State of New Mexico
 Energy, Minerals and Natural Resources

OIL CONSERVATION DIVISION
 1220 South St. Francis Dr.
 Santa Fe, NM 87505

SUNDRY NOTICES AND REPORTS ON WELLS
 (DO NOT USE THIS FORM FOR PROPOSALS TO DRILL OR TO DEEPEN OR PLUG BACK TO A DIFFERENT RESERVOIR. USE "APPLICATION FOR PERMIT" (FORM C-101) FOR SUCH PROPOSALS.)

WELL NAME: Penasco "IW" Shallow # 4 FIELD: Penasco Draw (Yeso S.A.)

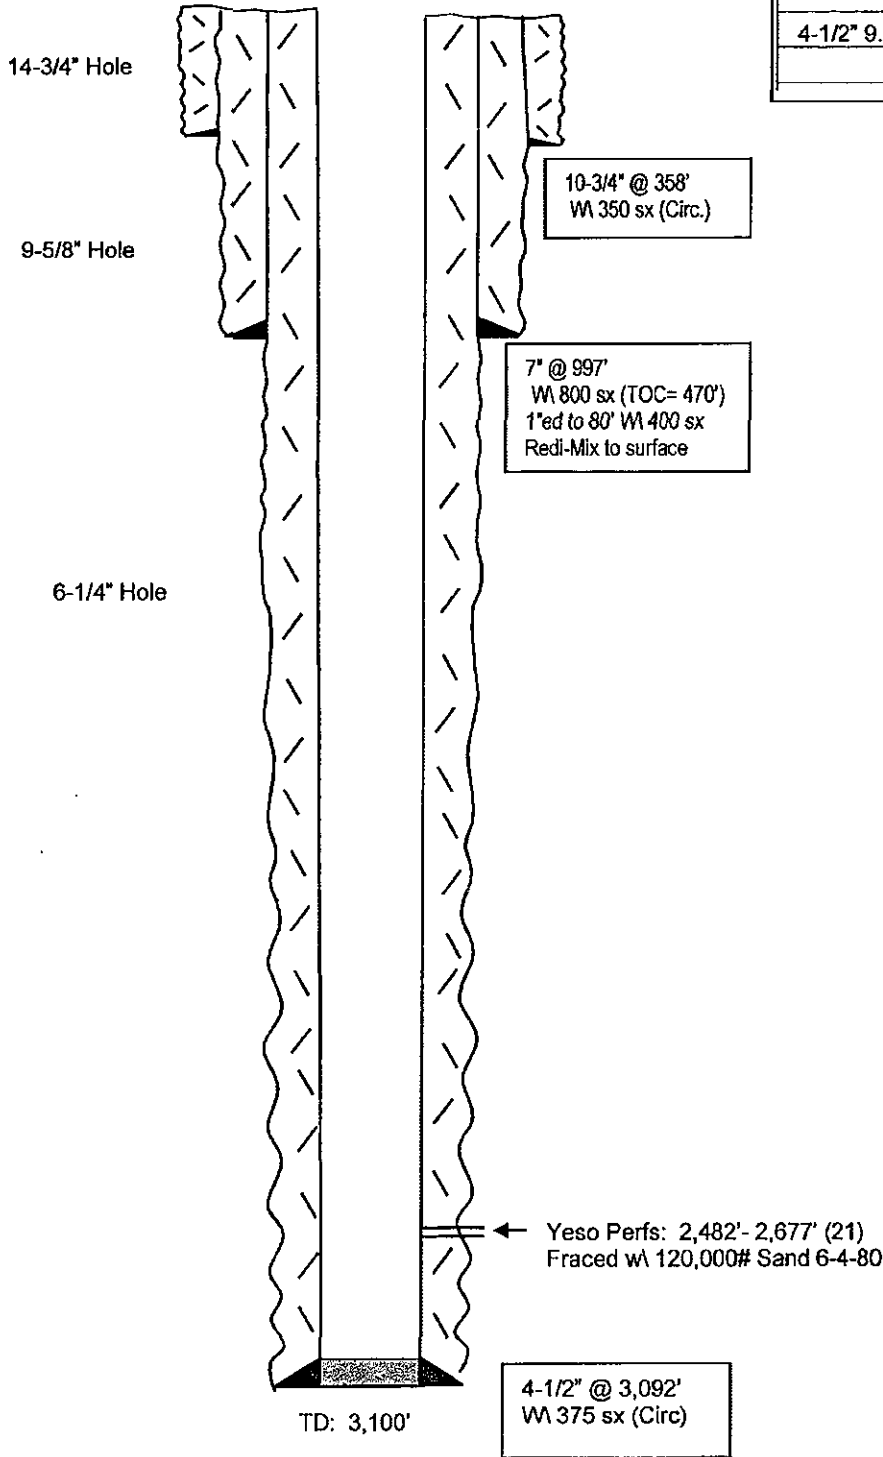
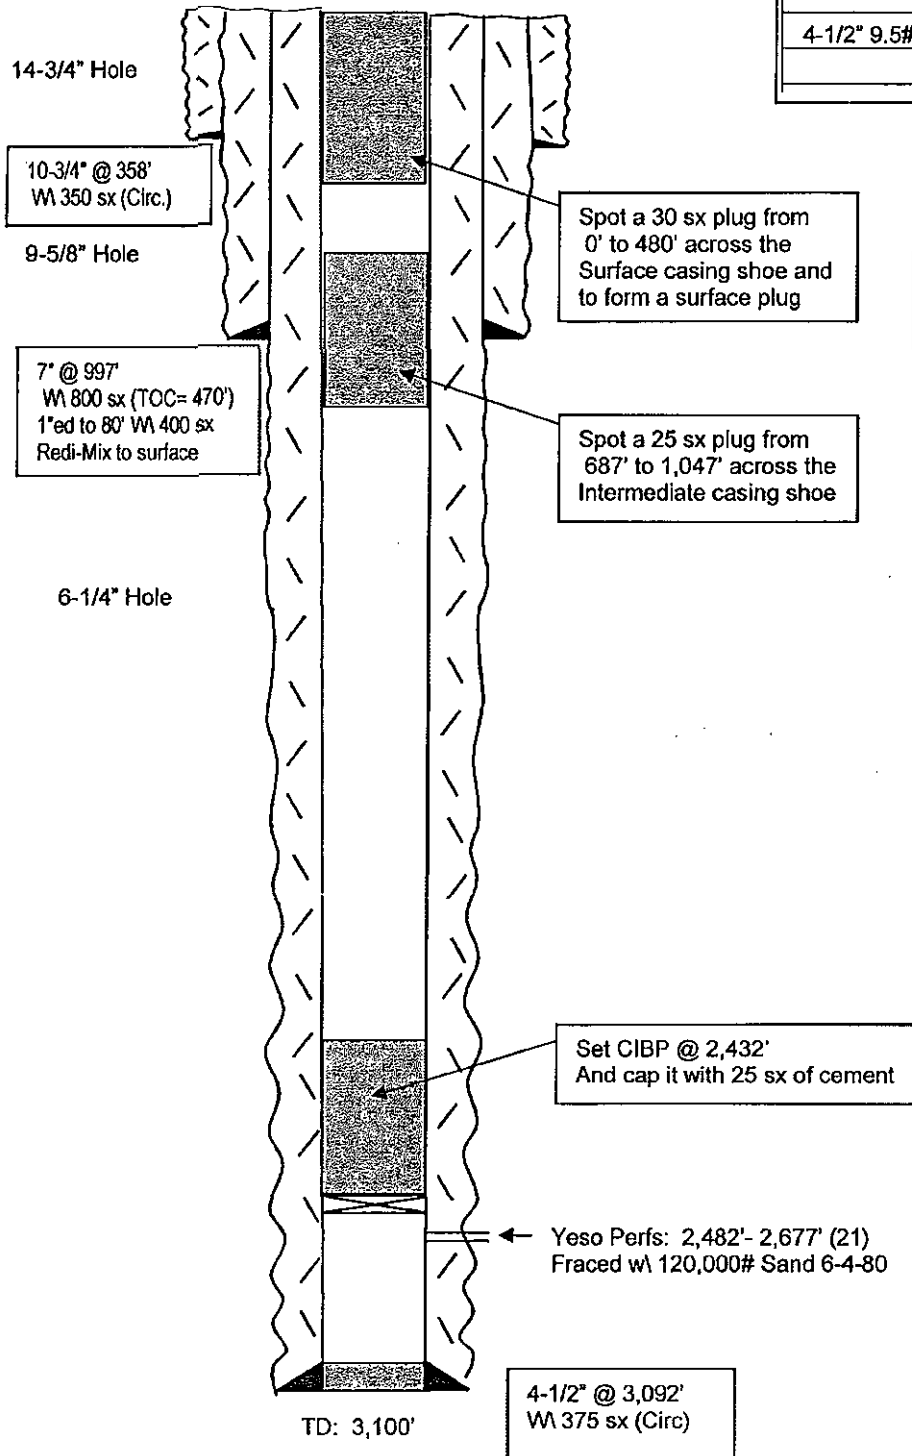
- MIRU all safety equipment as needed. NU BOP. No casing recovery will be attempted as production casing is cemented to the surface.
- Set a CIBP at 2432' and cap it with 25 sx Class "C" cement. This will leave a plug over open Yeso perms.
- Spot a 25 sx Class "C" cement plug from 687'-1047'. This will leave a plug across intermediate casing shoe. WOC and tag, reset if necessary.
- Spot a 30 sx Class "C" cement plug from 0-480'. This will provide a plug across surface casing and form surface plug. WOC and tag, reset if necessary.
- Remove all surface equipment and weld dry hole marker as per regulations.

1. Produced water **will not** be used during any part of the plugging & abandonment operation.
2. Notify NMOCD Dist. 2 office at least 24 hrs before beginning work.

7. Every attempt must be made to clean the well bore out to below the perms, before any plugs can be set, by whatever means possible.
8. **Cement Retainers may not be used.**

9. **Squeeze pressures are not to exceed 500 PSI, unless approval is given by NMOCD.**
10. **Plugs may be combined after consulting with and getting approval from NMOCD.**

11. **Minimum WOC time for tag plugs will be 4 Hrs.**
12. **19.15.7.16 : B.** In the case of a dry hole, a complete record of the well on form C-105 with the attachments listed in Subsection A of 19.15.7.16 NMAC shall accompany the notice of intention to plug the well, unless previously filed. The division shall not approve the plugging report or release the bond the operator has complied with 19.15.7.16 NMAC.
